Project Number: 5-C4006.00

P2M Walking & Cycling Link

Detailed Design Road Safety Audit

Proposed detail

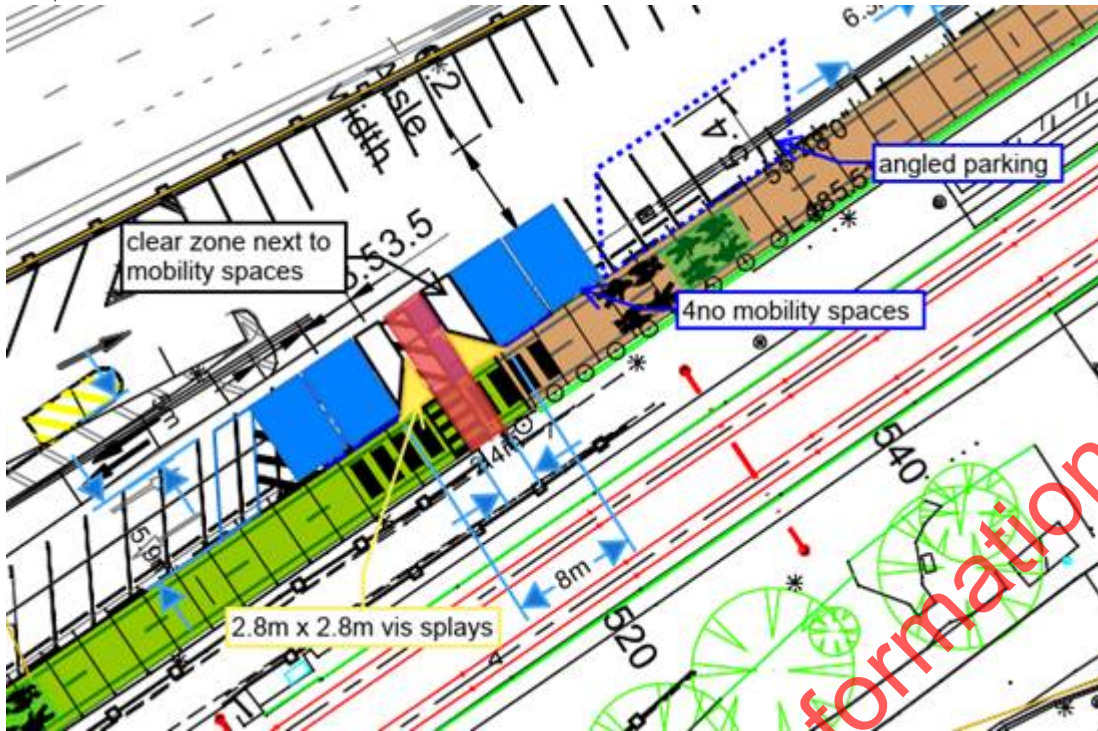
2.1 Pedestrian – cyclist conflict on path outside station Significant

Where the shared path travels at the same level as and adjacent to parking spaces within Petone Station, large vehicles (e.g. vans) are likely to obscure intervisibility between cyclists travelling along the path and pedestrians crossing the path, between the park and ride and the Petone Station platform.

Pedestrians may appear out from between parked vehicles directly onto the path, leaving northbound cyclists in particular very little time to react to brake or avoid a collision.

- 1 Ideally reconfigure the park and ride to ensure there is a (1.0-1.5m) gap between the front of vehicles and the shared path to improve intervisibility between pedestrians and cyclists.

- 2 If the above recommendation is not possible, install a painted buffer on the edge of the path where the vehicles abut so northbound cyclists ride closer to the centre of the path, out of the area where pedestrians may suddenly appear from between parked vehicles. A similar treatment is used where on-street parking is adjacent to a bi-directional facility in locations in Wellington City (Hutt Road – white dashed line, Oriental Parade – exposed aggregate separator strip).

- 3 Mark the warning block and slow symbol on the path in both directions prior to where cyclists would enter the section of path where these conflicts may occur, and where there are pedestrian desire lines, e.g. outside the stairs and where there are wider gaps between parking spaces abutting the shared path.

- 4 Where there are pedestrian desire lines because there is a gap between vehicles or a feature such as stairs up to the platform, mark zebra crossing bars (or other similar treatments) both across the shared path and in the parking aisle to direct pedestrians to these locations. The zebra crossings on the shared path should be proportional to the recently updated zebra bar widths and have limit lines to mimic the TCD crossing markings as closely as possible.

Frequency: <i>Crashes are likely to be Frequent</i>	Severity: <i>Death or serious injury is Unlikely</i>	Rating: <i>The safety concern is Significant</i>
Designer Response:	<i>In previous consultation with GWRC the capacity of the car park was a key issue. This resulted in the addition of the 'compensation car park' provision on the southern side of McKenzie Avenue. The number of parking spaces is part of a</i>

<p>property agreement and any change to the numbers would require approval of GWRC and changes to the property agreement</p> <ol style="list-style-type: none"> 1. This would have major implications on the layout and capacity of the car park. This will not be adopted. 2. Install 450mm hatch marking throughout the 0.5m margin zone ch441.6m to ch645.0m 3. Add "SLOW ZONE" markings and/or signage proposed at the entry point at either end of the shared area to supplement the other markings and changes (approx. ch20m & ch660m). 4. Zebra markings are included at the two crossing points, i.e. to the railway subway ramp (ch519m) and to the centre of the NB platform (ch574m). Whilst pedestrians may cross the car park and enter the shared path at virtually any point these are the two points where crossing of the path is intended. Exact layout to suit the TCD
<p><i>Safety Engineer:</i></p>	<p>1: The agreement with GWRC is still under negotiation and it may be possible to secure additional carparks, not to increase the gap but to provide additional LOS at crossing points, as discussed in debrief – refer to diagram in email (or Figure 5 in RTS-06). 2: Agree with suggestion 2. to include an edge-line 0.5m from the parking, preferably consistent with the marking used on the Hutt Rd cycleway (i.e. a dashed white line). 3: Agree with Designer response to add 'SLOW ZONE' markings to either end of the shared area. 4: Agree with Designer's response, but also note the importance to have at least white 4 bars on the path crossing (the change in the TCD rule is to have the space between the bars the same width as the bars themselves (i.e. 600mm) – this is to be scaled down for path crossings).</p>

<p><i>Client Decision:</i></p>	<p>GR: Designer to undertake recommendations 2, 3 & 4 as detailed in the Designer's Response and incorporating the Safety Engineer's comments. In addition, carparking layout will be modified to improve LOS at the southern designated crossing point as per proposed detail below. Please confirm asap what impact this change has on parking spaces.</p>
<p><i>Action Taken:</i></p>	<p>[</p>

2.2 Height/fall restraints insufficient

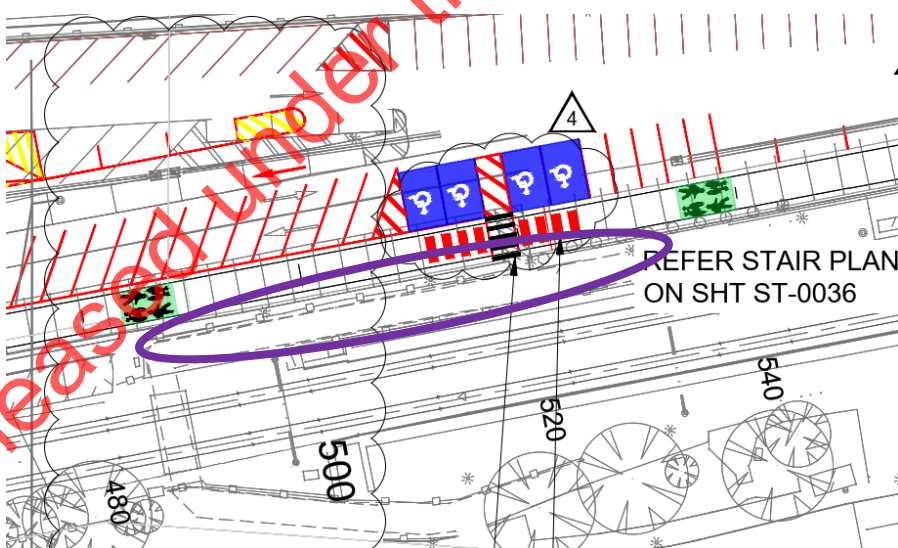
There are several locations in the project where there is a risk of fall, but where the existing fall restraints are insufficient to prevent cyclists, pedestrians or small children falling. These locations are:

- The balustrade beside the existing pedestrian underpass for Petone Station which will be directly adjacent to the shared path is not high enough for cyclists to prevent them falling off the shared path onto the underpass ramps.
- The balustrades on the steps connecting to the Petone Station platform from the park and ride do not have adequate measures to prevent small children falling through.

1. Ensure all fall restraints adjacent to the shared path and other areas with increased cycle demand are 1.4m high.
2. Ensure all fall restraints are designed in accordance with the NZ building code with regard to gaps appropriate for small children.

<p>Frequency: <i>Crashes are likely to be Infrequent</i></p>	<p>Severity: <i>Death or serious injury is Very Likely</i></p>	<p>Rating: <i>The safety concern is Moderate</i></p>
<p>Designer Response:</p>	<p>1. As discussed at the review meeting the 1.4m balustrade requirement is to be relaxed to 1.2m in the near future, hence adopt 1.2m where appropriate. The building code F4 Falling from Height requires protection of any potential fall of 1.0m or over.</p> <p>2. Subway balustrade, GWRC have recently replaced the balustrade to the railway subway. This is typically between 1.0m and 1.2m high above the concrete plinth or timber edge beneath. The gap below the</p>

<p>bottom rail is typically 170mm. The nearside edge of the path is between 0.9m and 1.2m from the balustrade and is separated by a standard kerb and gravel strip. Lighting columns for the car park are located in the gravel strip. Vertically, the top of the balustrade is typically >0.9m above the proposed path surface but does drop below 0.9m at the southern end adjacent the lower section of the balustrade. Taking into account the distance between the balustrade and the kerb/path edge the provision of an additional or higher balustrade is not considered necessary. However, the operators of the Station and car park (GWRC) will be advised of the SAT concerns. 3. Path adjacent the existing platform. The maximum fall height for the raised shared path section is 860mm at the central steps with the path falling back to the existing car park levels over approx. 20m either side. The proposed barrier is a guide and aide for path users. No change to the design proposed.</p>

Safety Engineer:	<p>Agree with Designer's response. 1.2m is adequate where the vaulting risk is low (as it is here). Less is acceptable where the fall is <1m and/or the barrier is set back from the through-route by >500mm.</p>
Client Decision:	<p>GR: No design change required – advise GWRC of safety concerns</p>
Action Taken:	<p>[</p>

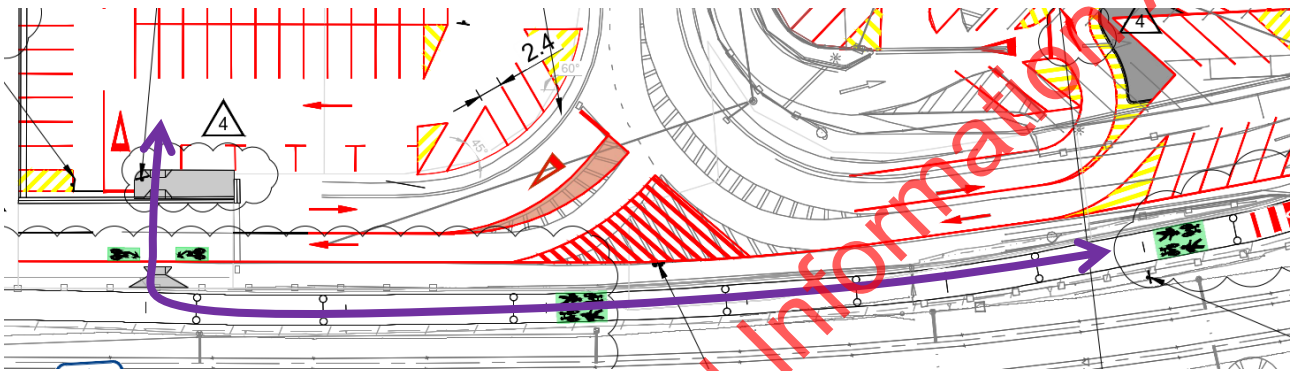
Waka Kotahi have requested the SAT comment on the safety implications of a fence between the cycleway and the carpark to only permit pedestrians to enter the shared path at certain locations.

The SAT do not support the use of a fence for the above purpose for the following reasons:

- The fencing would force pedestrians to take longer routes through the carpark (rather than the most direct route to the shared path) putting them at more risk of being hit by either reversing vehicles or vehicles travelling through the car park (compared to an option without a fence). Incidents between vehicles and pedestrians are much more likely to result in serious injury or death than between cyclists and pedestrians on a shared path. Children are particularly at risk with reversing vehicles.
- The fencing would likely reduce the width of the shared path as it would need to be offset from the parking, the effective width would also be reduced due to the shy distance of cycling adjacent to a continuous vertical element. This could in turn result in increased potential for conflicts between users on the shared path.

Noted, agree with the SAT

Noted, and also agree with the SAT and Designer

1 | DETAIL (McKenzie Ave Overbridge)

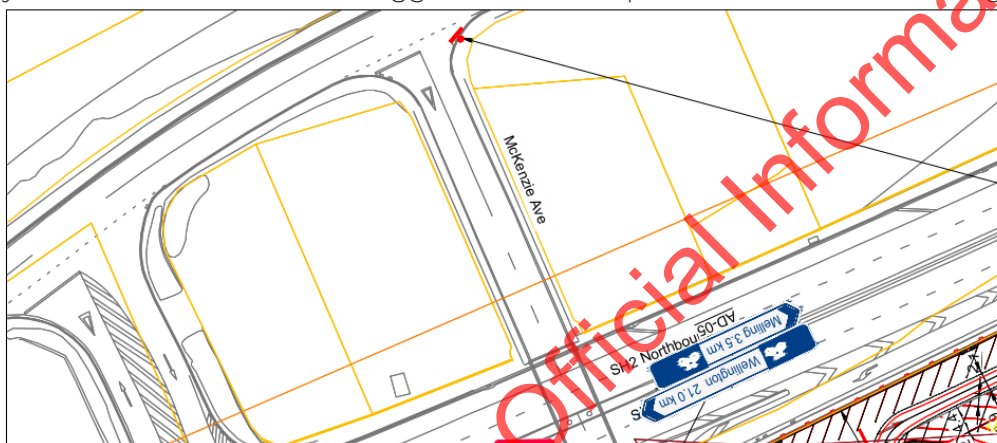
Pedestrians are presently not allowed on the MacKenzie Ave overbridge, which is appropriate given that there is no footpath and steep vertical geometry with poor visibility. However; the proposed wayfinding signs on either side of MacKenzie Ave overbridge include instructions for cyclists but do not include a suggested route for pedestrians to avoid walking over the overbridge.

- 1 Install wayfinding signs for pedestrians (via appropriate routes) near the overbridge.

Designer Response:	McKenzie Avenue has no footpaths and is unsuitable as a pedestrian route. This route is unlikely to be used by pedestrians and signage to the pedestrian overbridge is a decision for Waka Kotahi.
Safety Engineer:	Agree with SAT, noting that many walkers/runners exit the Korokoro Walkway nearby. Suggest wording of the proposed cycleway sign be changed from 'Shared Path' to 'Te Ara Tupua' (as 'Shared Path' reads like an invitation to pedestrians) and a new sign be added at this point. '<-- Pedestrian overbridge to Railway Station 300m' with a pedestrian symbol at the top.
Client Decision:	GR: There are already pedestrian no-go signs in place so not exactly an invitation. So instead of 2 new signs preferably the wayfinding information can be conveyed in one sign E.g. 'Te Ara Tupua' with a pedestrian symbol with arrow in direction of pedestrian overbridge 300m, and cyclist symbol with arrow in direction of McKenzie overbridge

3.3 Northbound cyclists from MacKenzie Ave riding the wrong way through the park and ride aisle

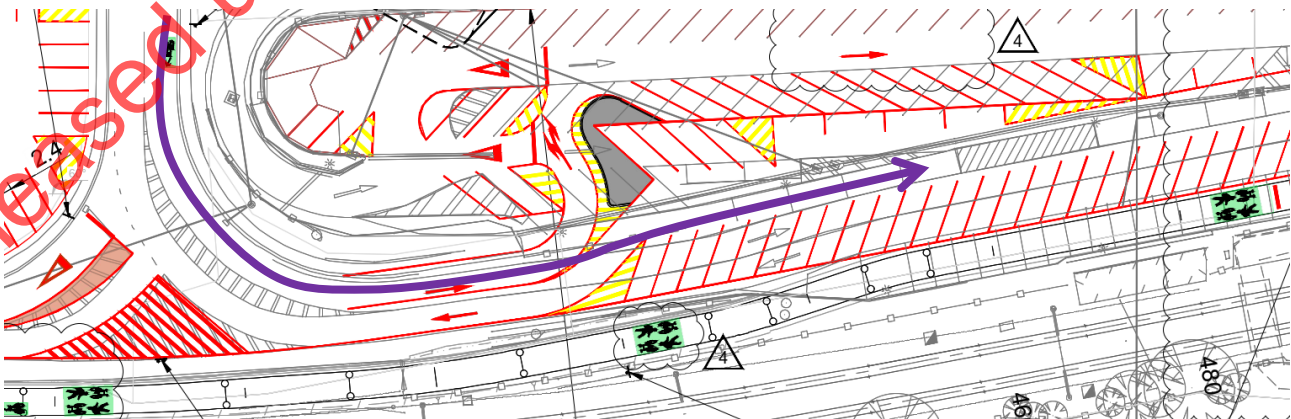
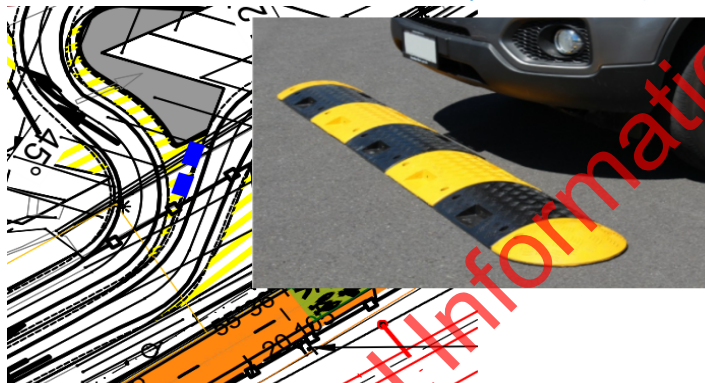
For cyclists heading northbound onto the path from MacKenzie Ave, the recommended route (shown through the markings on the plans) would take cyclists in the wrong direction before they can enter the path. This is likely to lead to cyclists riding the wrong way along the parking aisle, which increases the risk of drivers exiting angle parking spaces reversing into cyclists, as drivers would not expect to see or look for cyclists performing this movement.

- 1 If possible, install a drop-kerb from MacKenzie Ave to the path to prevent this movement through the carpark.

Designer Response: Although cyclist numbers heading northbound onto the path from McKenzie Ave are expected to be low it is correct that the route through the exit lane of the car park is more direct and potentially more attractive, despite the hazards identified, although not legal. The direct route through the car park indicated by the SAT above, is also used by KiwiRail as route for large maintenance vehicles to gain access to the track area north of the car park. KiwiRail vehicles cannot use the access direct off SH2 or the signed route through the car park. In order to discourage this route being used by cyclists install low speed bumps within the hatched area or immediately to the north (exact position tbc)

Safety Engineer: [Agree with SAT's suggestion to add a drop-kerb to allow for direct/coherent access between the path north of Petone Stn and Pito-One Rd, thus reducing the risk of riders cycling through the car park.

Client Decision: GR: Install a drop kerb and remove w-beam, as per sketch 3.3B below

3.4 Cyclists waiting to turn on MacKenzie Ave flush median

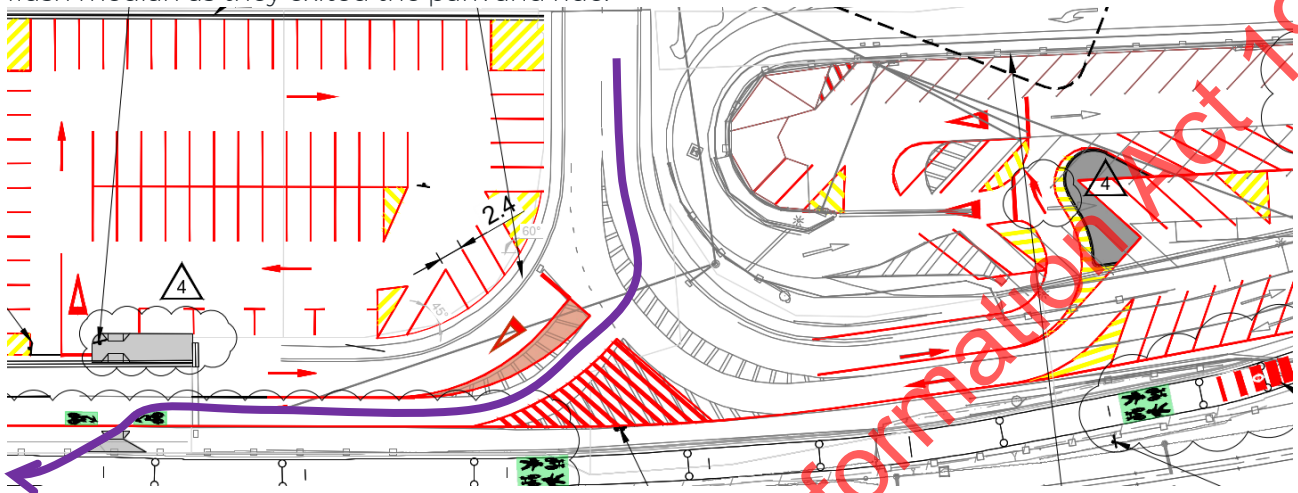
The flush median is in an area with poor forwards visibility due to the vertical geometry of the MacKenzie Ave overbridge and will be used by cyclists to wait while performing turning manoeuvres to the path. While on site, several vehicles were observed cutting the corner over the flush median as they exited the park and ride.

- 1 Install a turning treatment on the median for cyclists to ensure drivers are aware that cyclists use this area and are physically prevented from cutting the corner. Several good designs are presently installed on Evans Bay Parade in Wellington with green coloured surfacing on the flush median and safe hit posts preventing vehicle cutting into the flush median area.

Frequency: <i>Crashes are likely to be Occasional</i>	Severity: <i>Death or serious injury is very Likely</i>	Rating: <i>The safety concern is Significant</i>
Designer Response:	The right turn manoeuvre is and will continue to be used by college traffic, car park users and cyclists. Amend the existing central hatching to reflect these movements and add reflective road studs along the approach from the station car park to direct drivers to stay left	
Safety Engineer:	Agree with the Designer's response.	
Client Decision:	GR: Change as per Designer's response	
Action Taken:	[

4.1 Cyclist forward visibility and conflicts in underpass Moderate

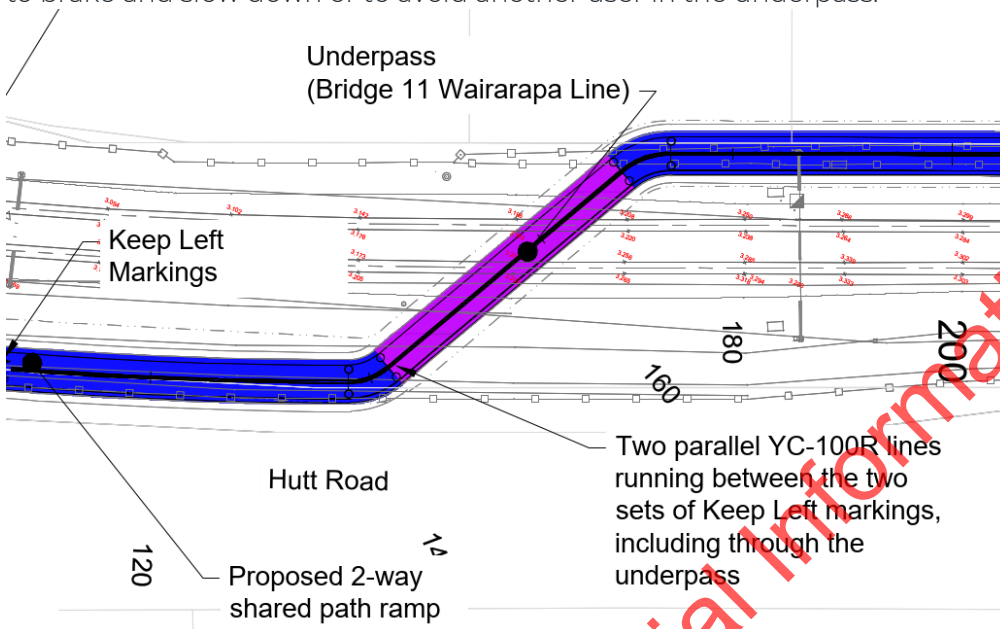
The horizontal and vertical geometry of the new underpass restricts forwards visibility. The SAT are concerned a cyclist travelling at speed down the underpass ramps would not have enough time to brake and slow down or to avoid another user in the underpass.

- 1 Install convex mirrors on the outside of the curves to allow approaching pedestrians and cyclists to see into the underpass from the ramps; or
- 2 Install a radar or other detection system with electronic warning signs to warn of approaching users from the opposite direction on both approaches to the underpass.

Frequency: <i>Crashes are likely to be Common</i>	Severity: <i>Death or serious injury is Unlikely</i>	Rating: <i>The safety concern is Moderate</i>
Designer Response:	[The lining arrangement through the underpass is considered appropriate. The approach signage and markings have been repositioned and added to in order to reinforce the low speed and shared environment. No further action is proposed	
Safety Engineer:	[Agree with the Designer's response. Encouraging better lane discipline within the underpass itself could be achieved by including a pair of direction arrow markings around Ch 160. Convex mirrors are an option to reconsider after we see how well the path operates.	
Client Decision:	GR: Design as per Designer's response plus direction arrow marking within the underpass (to encourage pedestrians to stay in their lane)	
Action Taken:	[

4.2 Red blocks reflectorised paint skid resistance Moderate

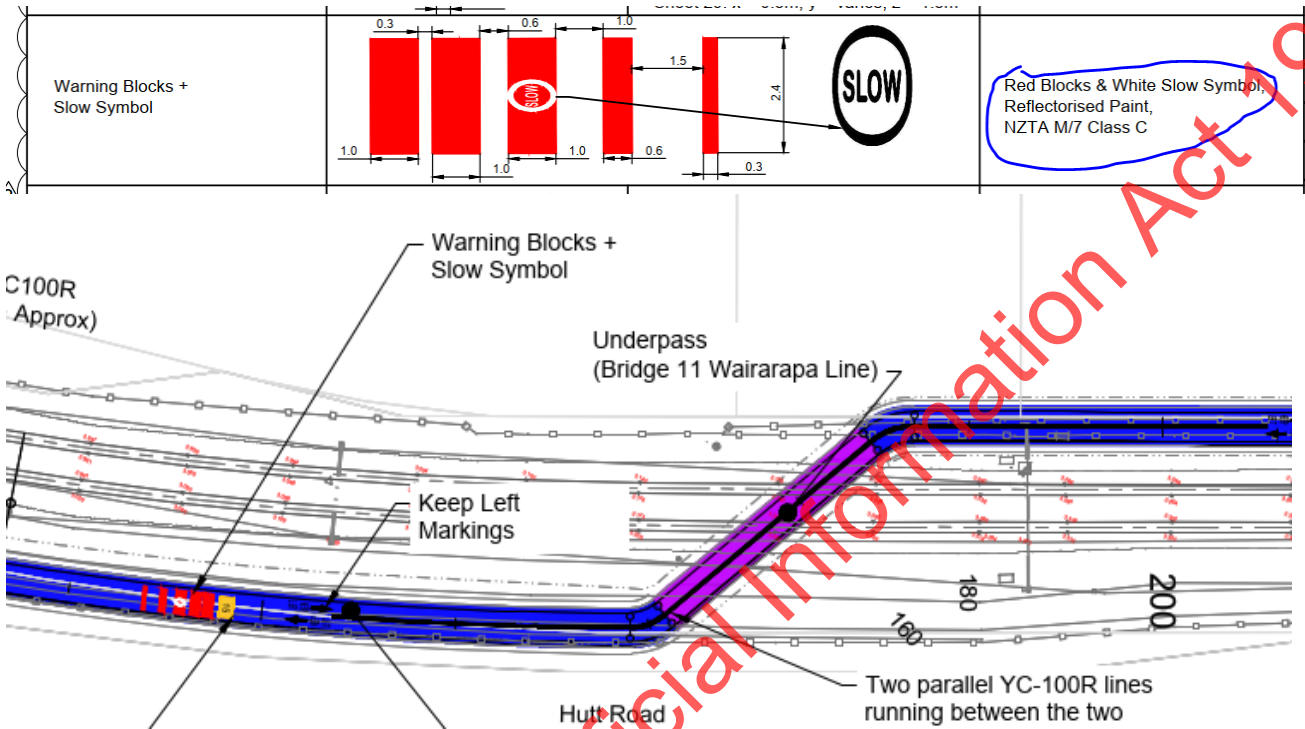
On the pavement marking schedule, the red warning blocks and slow symbol materials are reflectorised paint. In the line marking and sign plans, the warning blocks and slow symbol are

marked on the ramps into the underpass, where cyclists travelling down the ramps towards the underpass will brake to reduce speeds prior to the curve into the underpass.

Reflectorised paint does not have good skid resistance, and large blocks of reflectorised paint should be avoided in areas where there are high braking demands to avoid loss of control under braking.

- 1 Materials for red warning blocks should all be calcined bauxite or otherwise in accordance with the P33 coloured surfacing specification

Frequency: Crashes are likely to be Common	Severity: Death or serious injury is Unlikely	Rating: The safety concern is Moderate
Designer Response:	The markings specifications have been amended.	
Safety Engineer:	Agree with Designer's response.	
Client Decision:	GR: Design as per Designer's response	
Action Taken:	[

5.2 Wayfinding signs

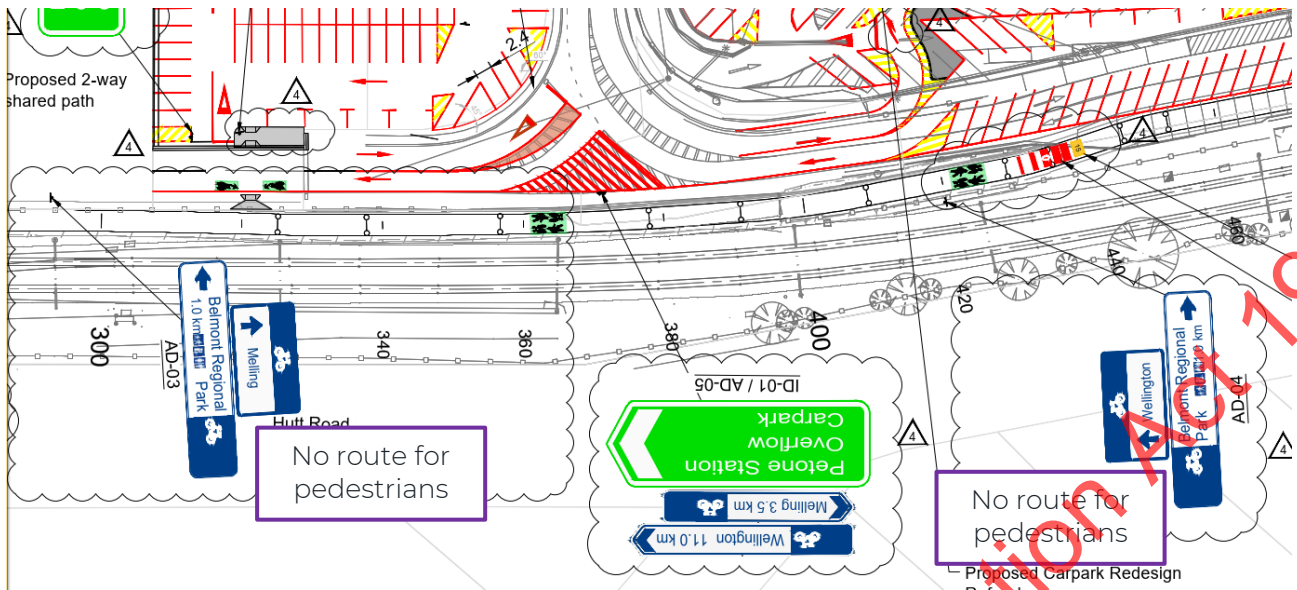
There are several areas of the project where wayfinding signs provide directions for cyclists to/from the shared path, but do not provide any directions for pedestrians where there is already a better existing route for pedestrians to follow than walking along the path. Examples include:

- Guidance directing pedestrians along the footpath adjacent to Hutt Road and then through the existing underpass to Petone Station.
- Pedestrian access to Belmont Regional Park near MacKenzie Ave overbridge.

In addition, there are several areas where the wayfinding signs do not provide consistent information for both pedestrians and cyclists, in terms of following the advance direction, intersection direction and confirmation direction methodology, which may result in less familiar users not turning off in the correct location to go where they intend.

- 1 Amend wayfinding signs to inform northbound pedestrians of the existing footpath and underpass route to Petone Station at the southern terminus of the project.
- 2 Install wayfinding signs for the pedestrian route to Belmont Regional Park.
- 3 Review destinations along the route with the preferred route through the project area separately for pedestrians and cyclists to ensure advance direction, intersection direction and confirmation direction signs are installed in appropriate places.

Frequency:	Severity:	Rating:
Crashes are likely to be Infrequent	Death or serious injury is Very Unlikely	The safety concern is Minor
Designer Response:	<p>Amend wayfinding signs to inform northbound pedestrians of the existing footpath and underpass route to Petone Station at the southern terminus of the project.</p> <p>The station office is on the southbound platform and is a likely first destination for passengers heading in either direction. The existing subway for the station gives access to the northbound platform without accessing the shared path.</p> <p>Additional pedestrian signage at the new subway is not considered necessary.</p> <p>Install wayfinding signs for the pedestrian route to Belmont Regional Park.</p> <p>Add appropriate signage via the existing Petone Station overbridge (subject to the approval of GWRC).</p> <p>Review destinations along the route with the preferred route through the project area separately for pedestrians and cyclists to ensure advance direction, intersection direction and confirmation direction signs are installed in appropriate places.</p> <p>Noted</p>

Safety Engineer:	<p>1: Agree with SAT. Visitors to the area may not be aware of the existence of the old subway. Wayfinding at the intersection of Hutt Rd and the new subway would be helpful for them (and potentially reduce pedestrian use of the SUP subway). 2: Agree with Designer's response.</p>

Client Decision:	GR: Design as per Safety Engineer's response
Action Taken:	[
